**Application for Amendment of  
USNRC Source Materials License SUA-1534  
Marsland Expansion Area  
Crawford, Nebraska**

**Response to Request for Additional Information (RAI)  
Dated July 03, 2013**

**Prepared by  
Crow Butte Resources, Inc.  
86 Crow Butte Road  
Crawford, Nebraska 69339**

**December 2013**

**FIGURE 1.3-1  
CROW BUTTE RESOURCES INC.  
CURRENT LICENSE AREA  
AND PROPOSED EXPANSION AREAS**

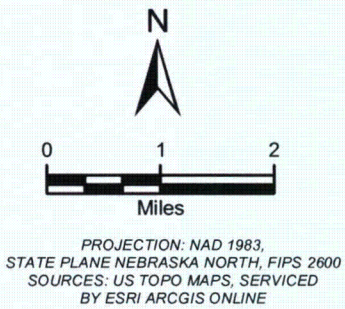
**Basis for Request** NUREG-1569 in Section 2.1.2 states that the scale and clarity of the maps should be adequate to conduct the necessary environmental and safety reviews. Section 2.1 of the TR references Figure 1.3-1 as a primary reference to indicate topographical figures, drainage and surface water features; nearby population centers; political boundaries; and principal highways, railroads, transmission lines, and waterways. Because of lack of a complete legend and lack of contrast to allow identification of separate items in Figure 1.3-1, it is difficult to identify all roads, railroads, etc. In addition, the large pink gridlines obscure or completely hide some of these items (e.g, political boundaries, a road going directly through the Marsland site, etc.).

<p><u>Request for Additional Information</u> Please provide an appropriate legend and more clearly mark the map with contrasting colors so that the items in NUREG-1569, Acceptance Criterion 2.1.3(4), can be readily identified. The use of separate maps to highlight these items may also help clarify their locations. A map without gridlines or another method of identifying gridline (e.g., hash line) should also be used to avoid obscuring underlying highlights. Other maps using gridlines should also be reviewed and revised, as necessary, to ensure the gridlines are not obscuring pertinent information.</p>	
<p><b>RAI 3 Description of Deficiency</b> Staff cannot complete its evaluation of NUREG-1569, Acceptance Criterion 2.2.3(1)(b).</p> <p><b>Basis for Request</b> NUREG-1569, Acceptance Criterion 2.2.3(1)(b), states that projected life of facility water use should be provided. In Section 2.2.4 of the TR, the applicant states that “future water use within the MEA and AOR will likely be a continuation of present use” and that “it is unlikely that any irrigation will be developed within the license area.” However, as the applicant appears to only lease the land and not own the land, there appears to be no controls over the installation of new wells in the MEA or AOR.</p> <p><b>Request for Additional Information</b> Please provide information on if and how the development of new wells in the MEA or AOR during facility operations will be identified or prevented. Also, if new wells are installed by other than the applicant, please describe any actions that will be taken to protect those wells. If any new wells in or near the MEA have been identified since the survey the license application is based on was completed approximately August 23, 2011), please provide information about those wells.</p>	<p>Cameco Response: By operation of the leases, no new wells will be installed within the license area without CBR permission.</p> <p>There is no obligation to prevent new wells from being installed in the Area of Review. The Nebraska Department of Natural Resources registered well database will be reviewed annually, and where appropriate, arrangements will be made to monitor any new wells.</p> <p>Between August 23, 2011 and September 16, 2013, no new private wells have been registered within the AOR. Section 2.2.4 was revised accordingly.</p>

Cameco Response: Figure 1.3-1 was revised in order to improve the contents of the legend and drawing, which should help with defining all of the features depicted on the map. Other figures have also been reviewed and revised for better clarity. Other figures in the document that also provide features of interest that are not presented in this particular figure, such as Figures 1.3-2, 1.4-1, 1.7-3, 1.7-5, 2.2-1, 2.2-2, 2.2-3, 2.2-4, 2.7-1, 2.7-4, 2.7-6, 2.8-1, 2.8-2, 2.9-2, 2.9-3, 2.9-8 and 4.2-1.

**FIGURE 1.7-5**  
**GENERAL ARRANGEMENT**  
**SATELLITE FACILITY VIEW**

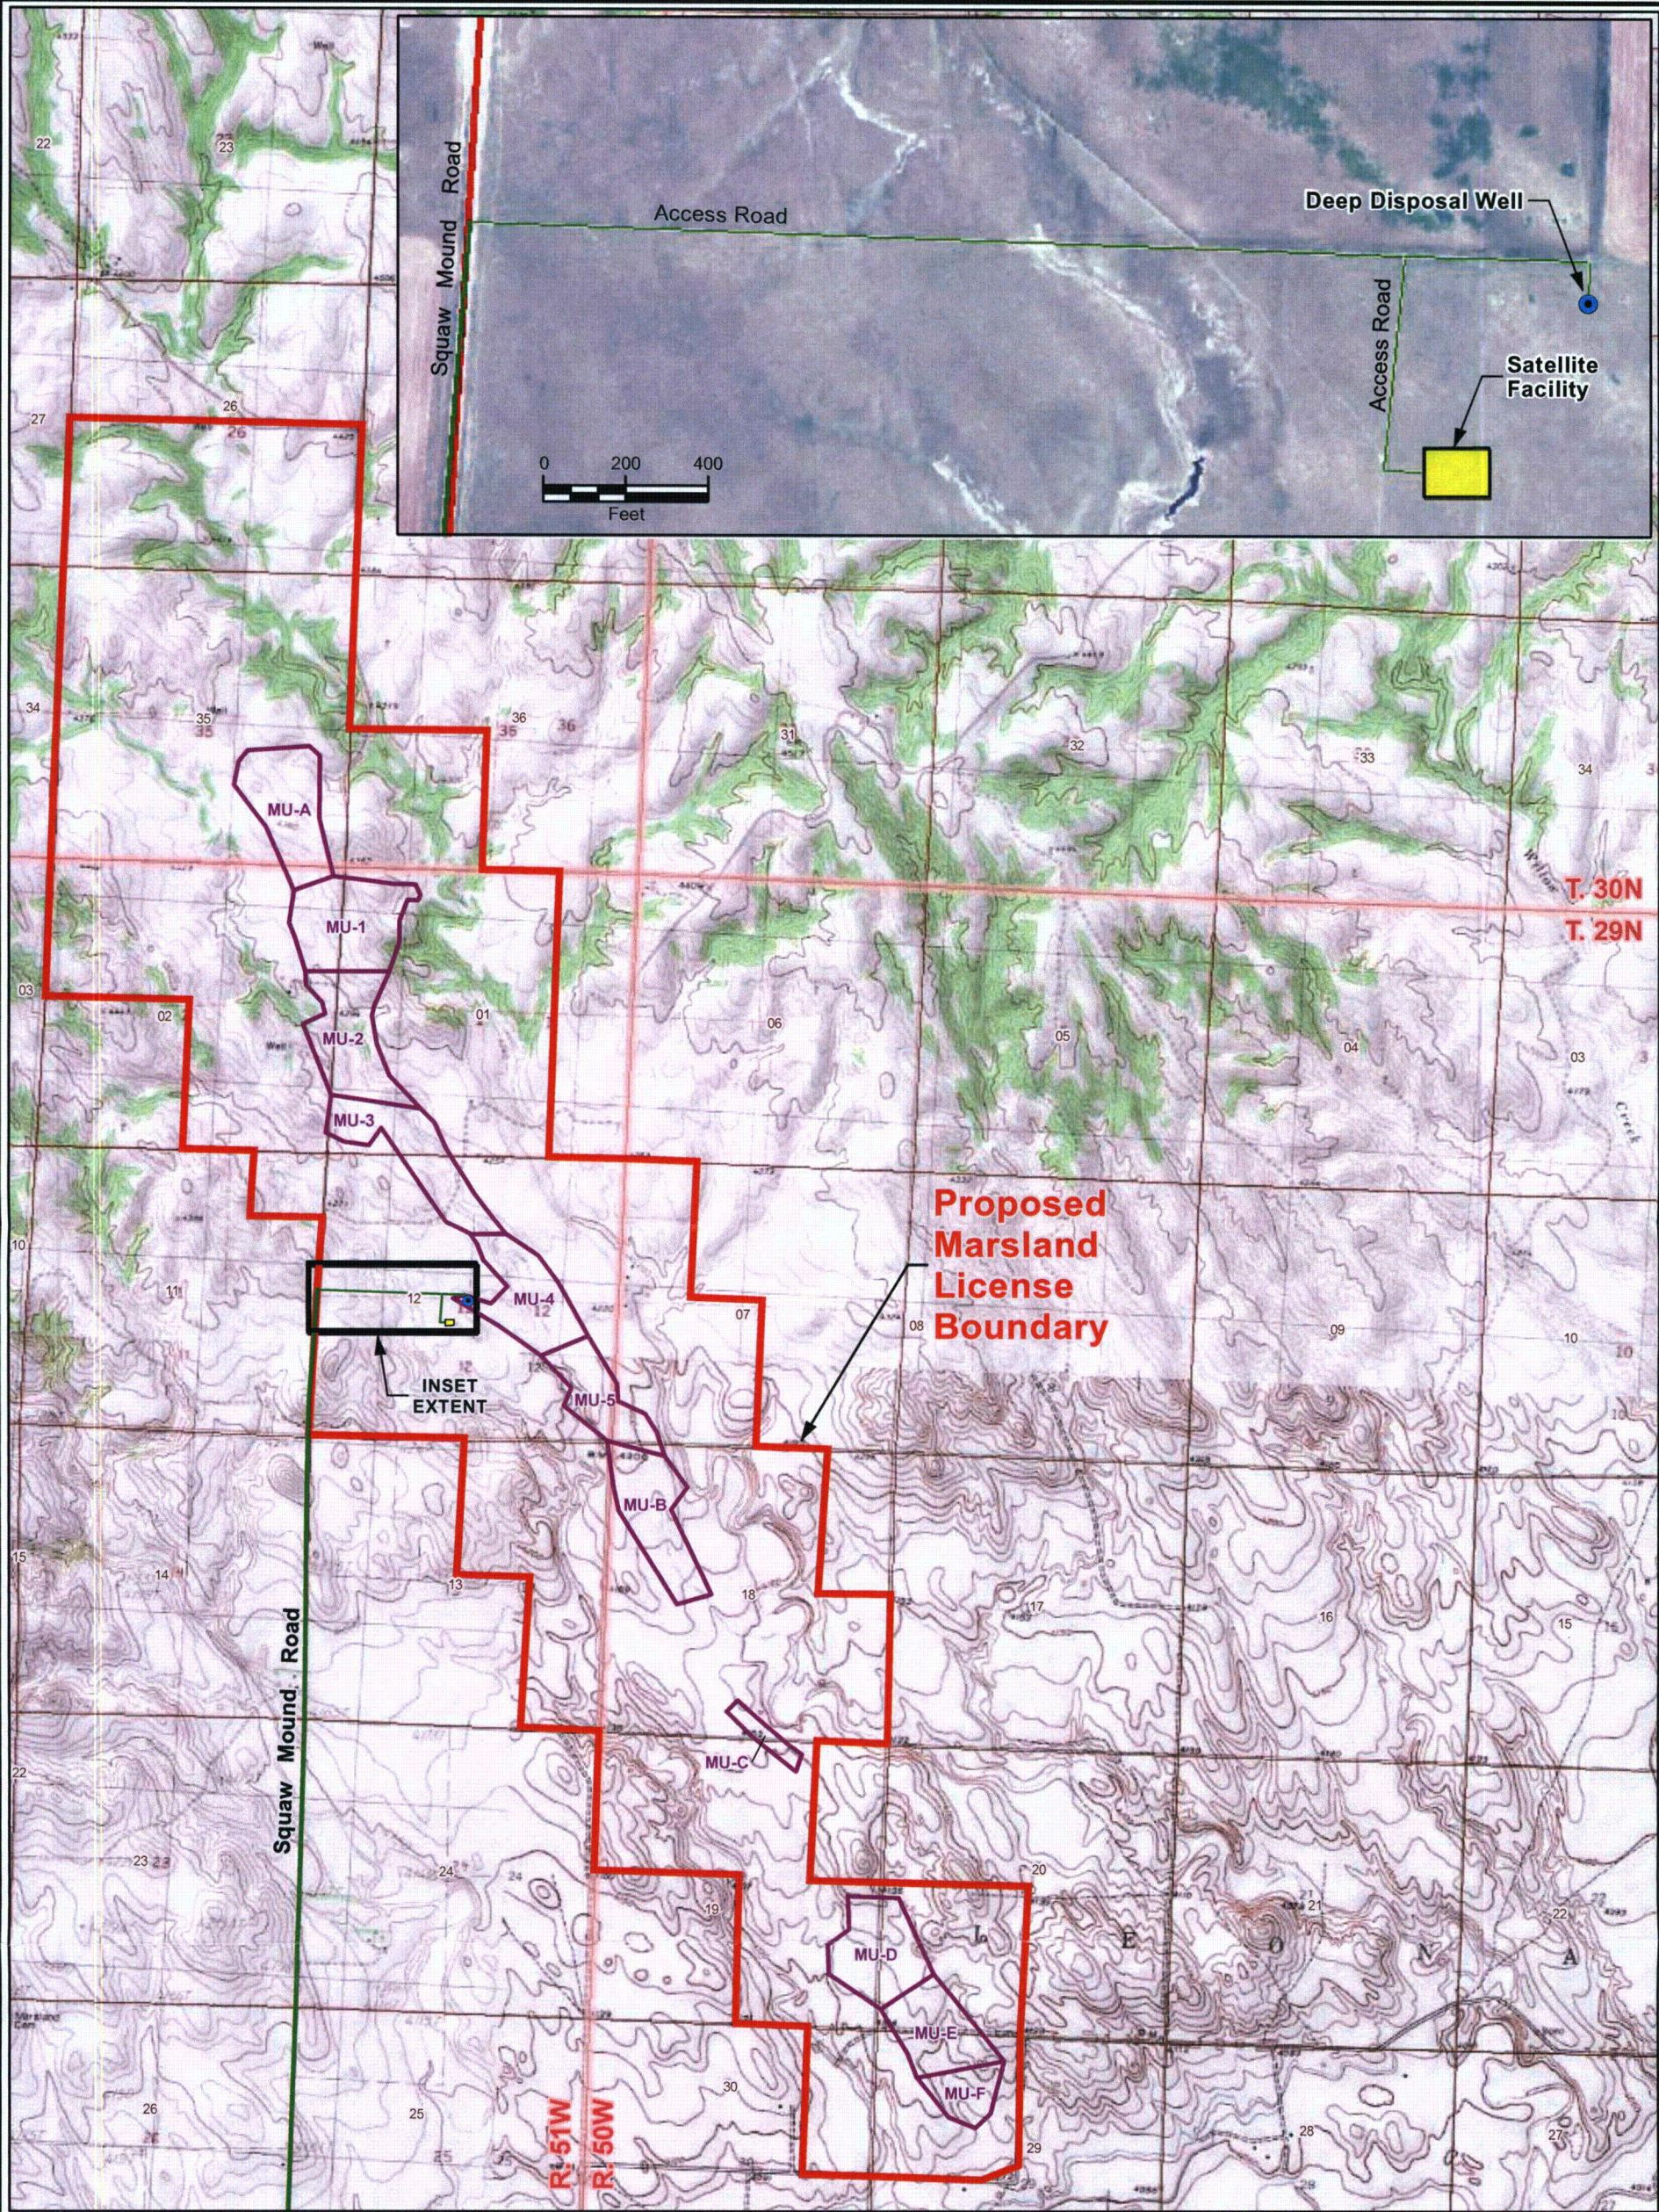
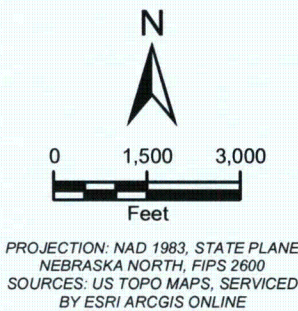
The inset in Figure 1.7-5 of the TR identifies a chain-link fence around a restricted area. However, this identification of the restricted area conflicts with the text in Section 5.6.2 of the TR where it states, “the security fence surrounding the satellite facility serves as a control for industrial/property protection purposes with the restricted area noted in red on Figures 1.7-5 and 5.7-2.” As the legend for Figure 1.7-5 of the TR indicates the red markings are for the Proposed MEA, this statement appears incorrect. In addition, Figure 5.7-2 of the TR identifies the restricted area as only being portions of the building and does not appear to include the entire fenced in satellite area as identified in Figure 1.7-5 of the TR.

Section 2.1 of the TR states that Figure 1.7-5 of the TR shows the proposed location of fencing, among other items. Section 5.7-2 of the TR states, “the fencing around the well field will control access and protect industrial property,” but no fencing around the well fields is identified in Figure 1.7-5 of the TR.

**Request for Additional Information** The text and/or figures should be revised to clearly identify what is considered to be part of the restricted area and to correctly identify any fencing mentioned in the application. In addition, a description of the type of fencing, if not already identified, should be included.

Cameco Response: Figure 1.7-5 was revised to delete the incorrect reference to the restricted area fencing around the satellite building and to clarify the license boundary. There will be no fencing around the satellite building; only perimeter fencing will be present. Section 2.1 was revised to delete the reference to the fencing shown on Figure 1.7-5. Section 5.6 was revised to clarify proposed fencing associated with controlled and restricted areas.
